Quality Assurance Division

Mega Drive 1 VA4 - PAL

008

## SUBJECT:

### Circuit Change

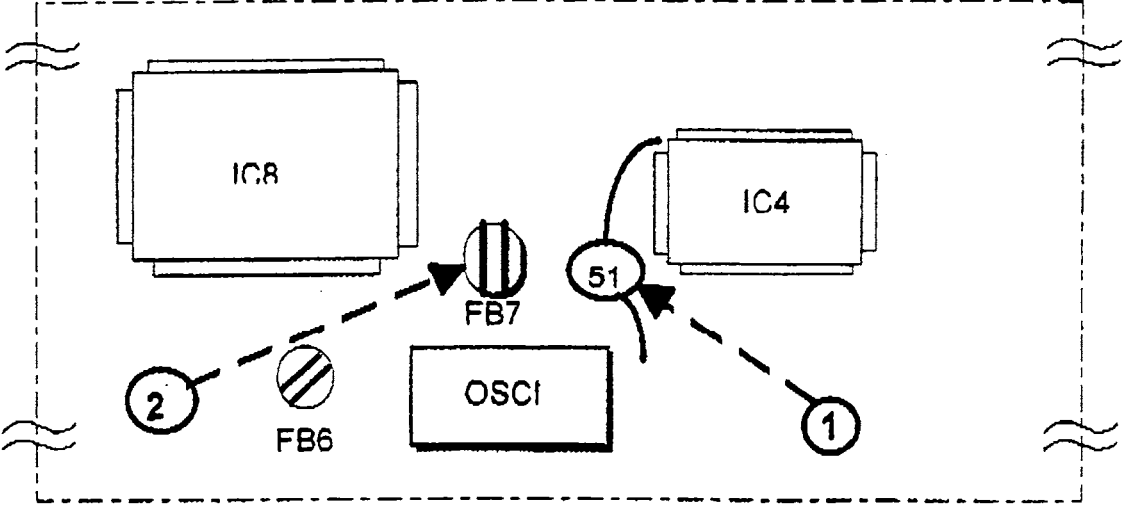
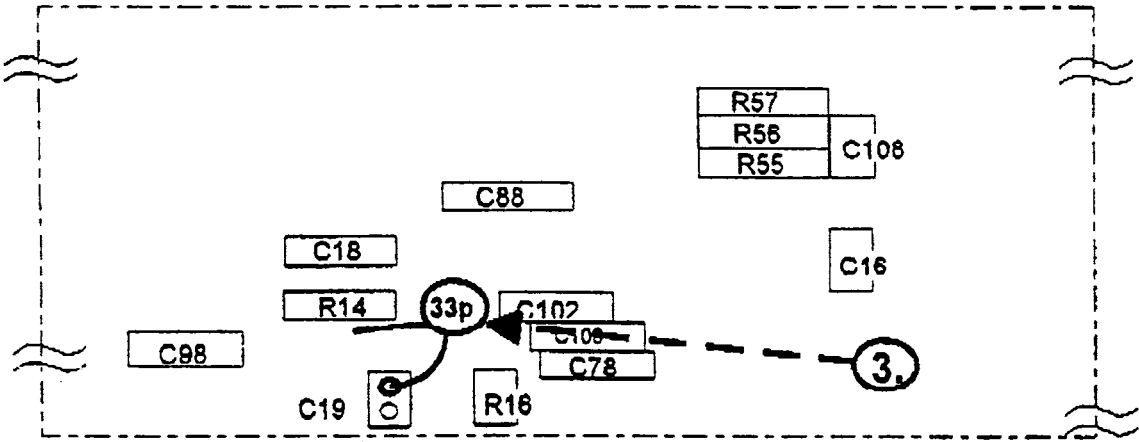
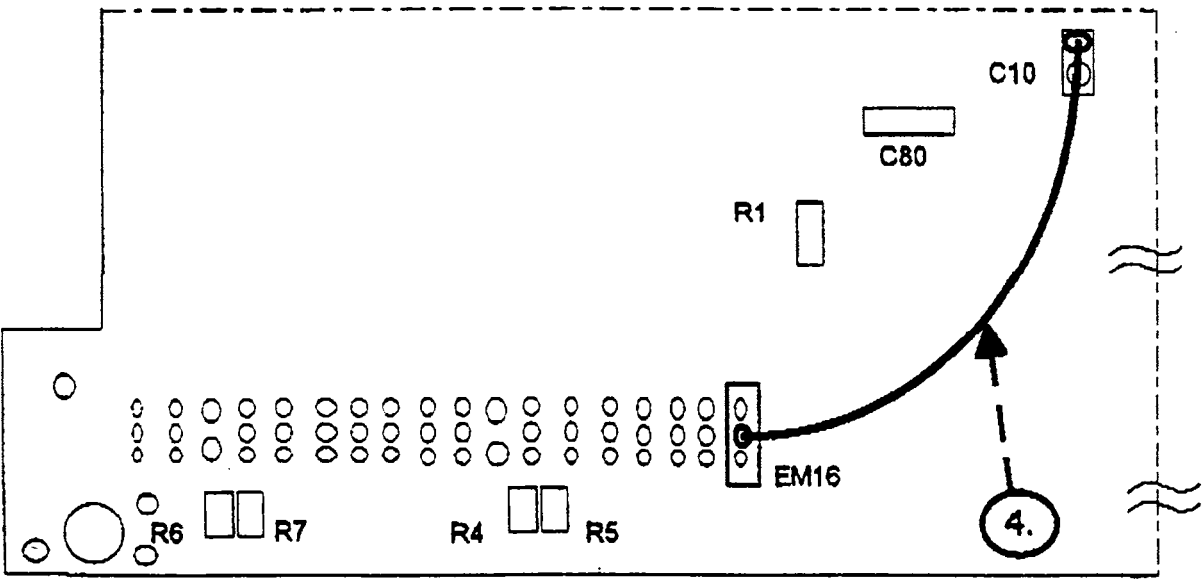
The signal shape of the EDCLK must be improved to fix this problem, see CIRCUIT CHANGE below.

1. Change C92 from a 51pf capacitor to a 33pf ceramic capacitor. It is important that the capacitor be located next to IC4.
2. Remove FB7 and insert a jumper wire or short out FB7.
3. Remove C112. This is a 33pf ceramic capacitor that has been added to the back side of the circuit board. It is connected to the top side of C19.
4. Add a jumper wire to the back side of the circuit board between the top of C10 (this should be the same point electronically as IC4 pin 31) to ground (the middle pin of EM16 is recommended). Please be sure to use a slightly heavier gage of wire to ground (heavier than AWG28 with a wire diameter of 0.38mm).

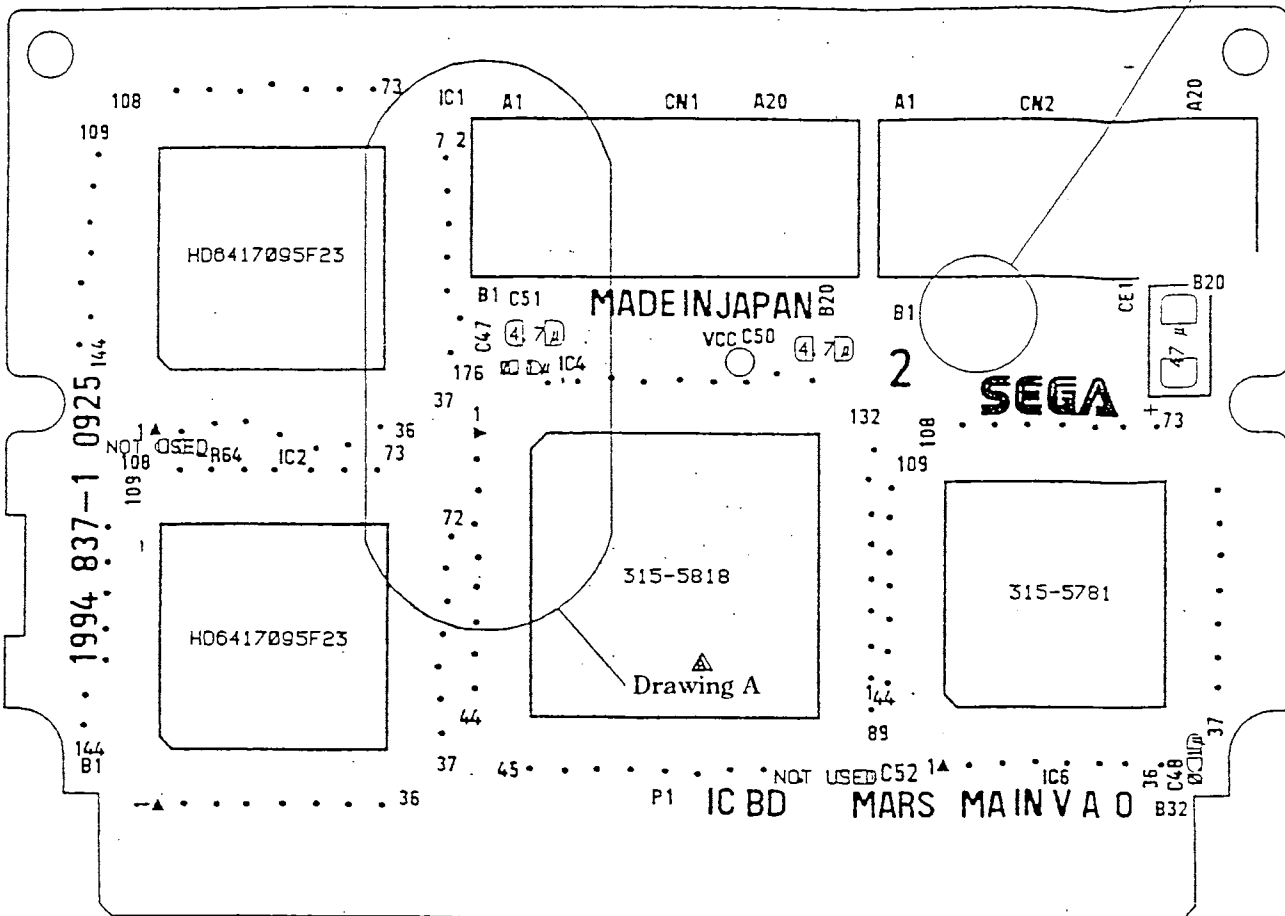
An SCA (Standard Cell Array) type of IC4 has replaced the gate array type originally used on 32X. Due to this change in IC types two capacitors (C96 & C97) have been added. Please refer to the chart below for possible configurations you may encounter.

Value of C96 & C97 depends on part number of IC1/IC2	IC4 (SCA) C96 & C97	IC4 (Gate Array) C96 & C97
IC1 & IC2 Pt# 315-0922	47 pf	NOT INSTALLED
IC1 & IC2 Pt# 315-0922A	47 pf or 100 pf	NOT INSTALLED
IC1 & IC2 Pt# 315-0988	100 pf	NOT INSTALLED

- Two 100 pf capacitors have been incorporated into the 32X VA2 version.
- Two capacitors are added to the 32X VA0/VA1 versions as per the above chart

Rear side (termination side) of MD1(VA4) Circuit Board.

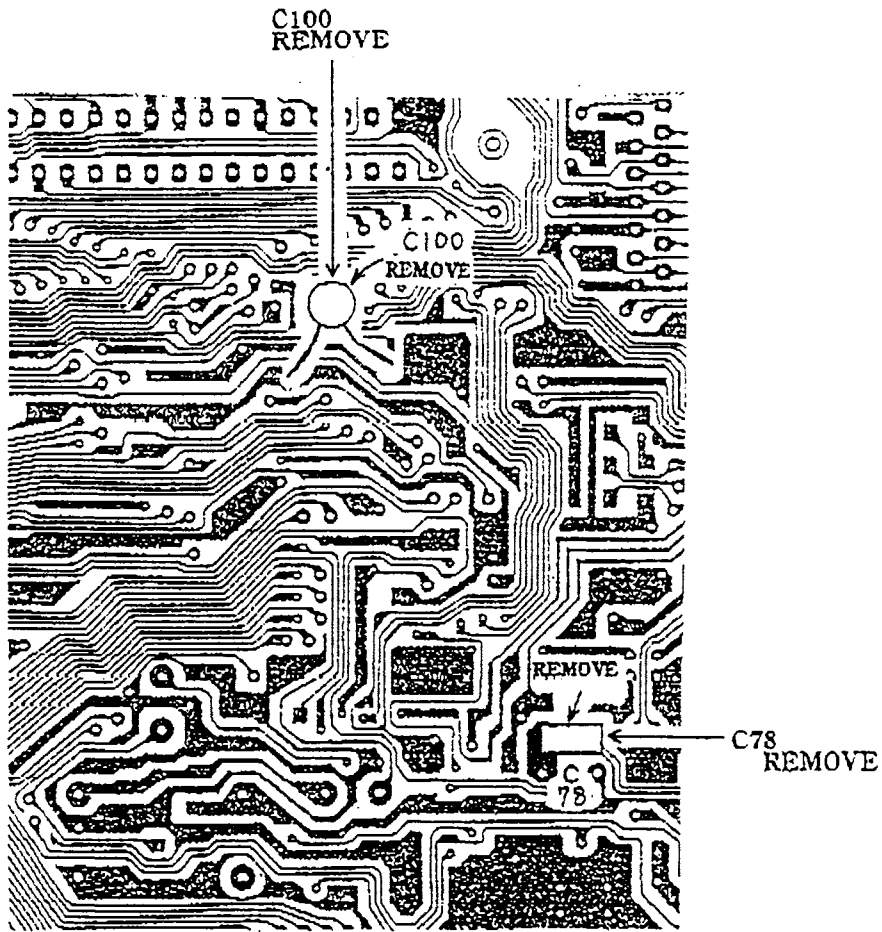
The signal quality of the VCLK signal has been identified as the problem area. By removing two capacitors in the VCLK signal line signal quality is greatly improved.

Remove C78 and C100.

MD1 VA5, VA6 改造方法 (片面パターン図)

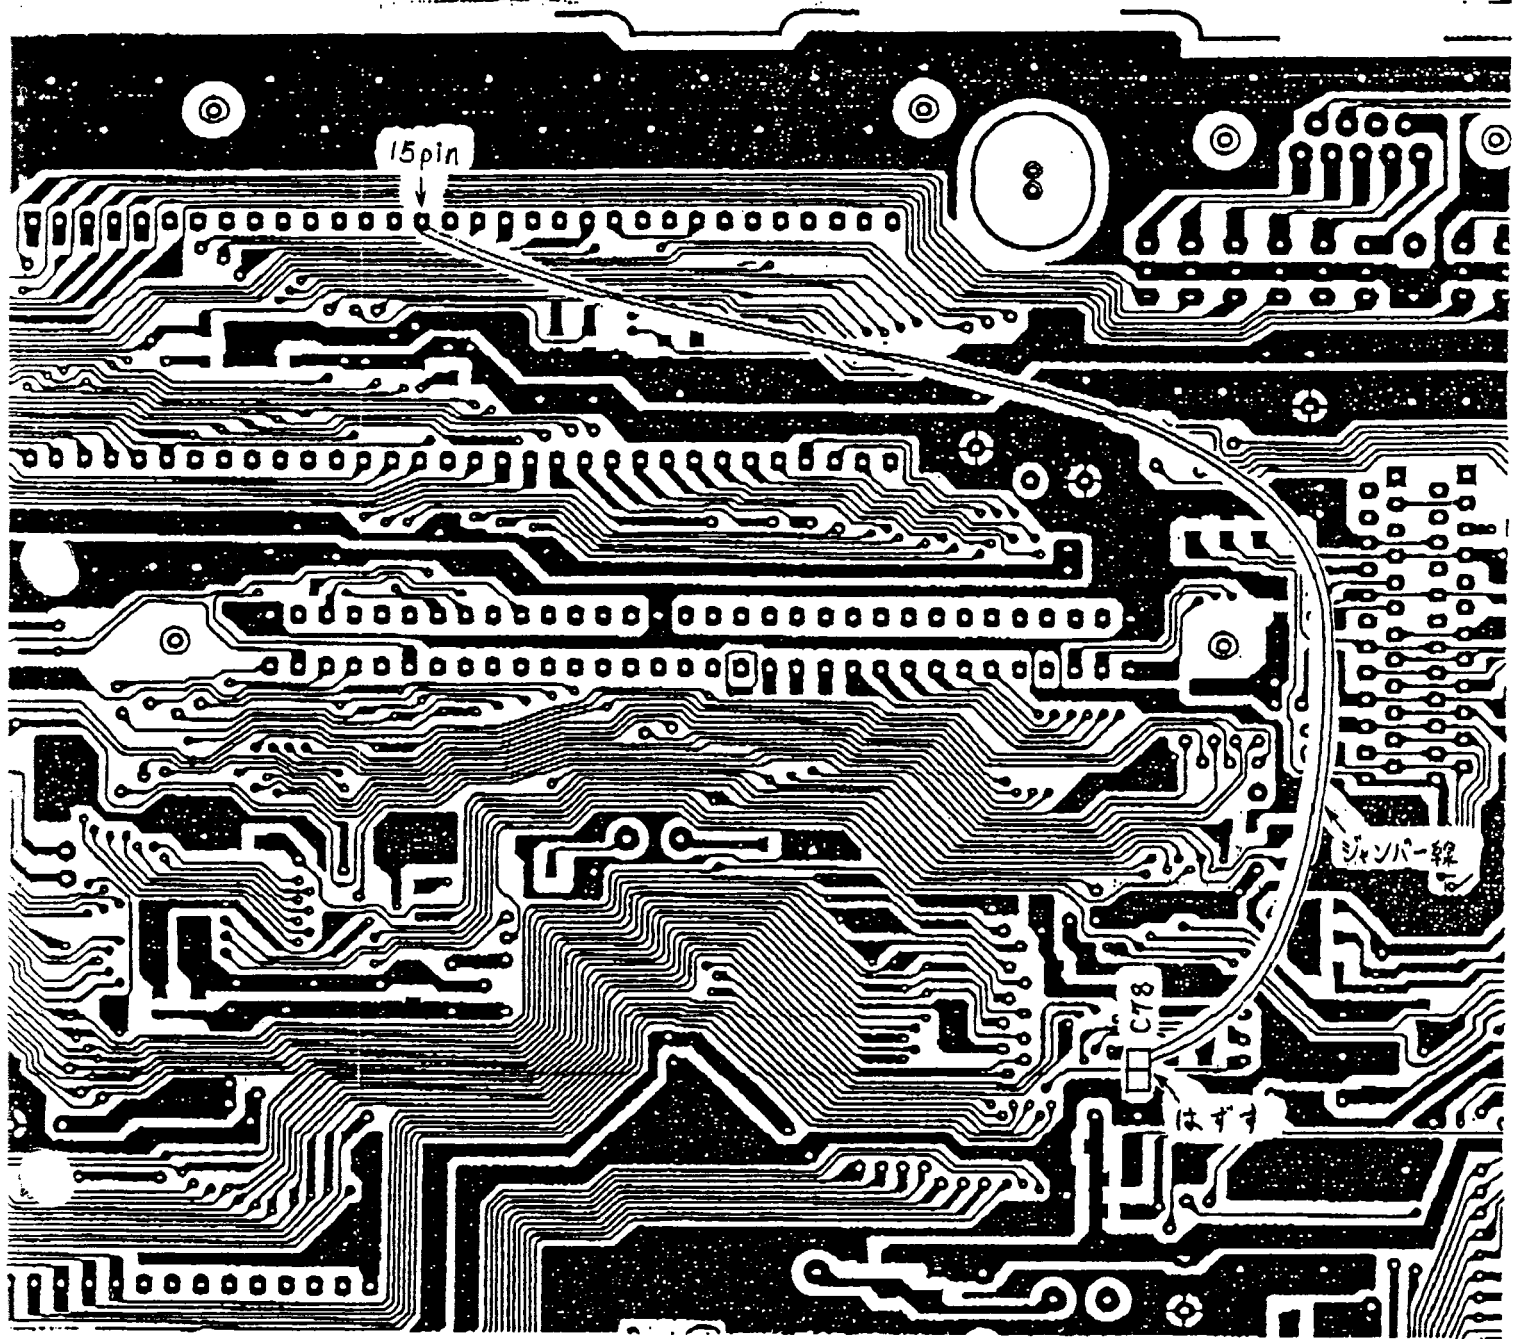
The signal quality of the VCLK signal has been identified as the problem area. By removing one capacitor and adding a jumper line in the VCLK signal line, signal quality is greatly improved.

Remove C78 and add a jumper line from IC 1, pin 15 to the signal side of the pad where C78 has been removed.
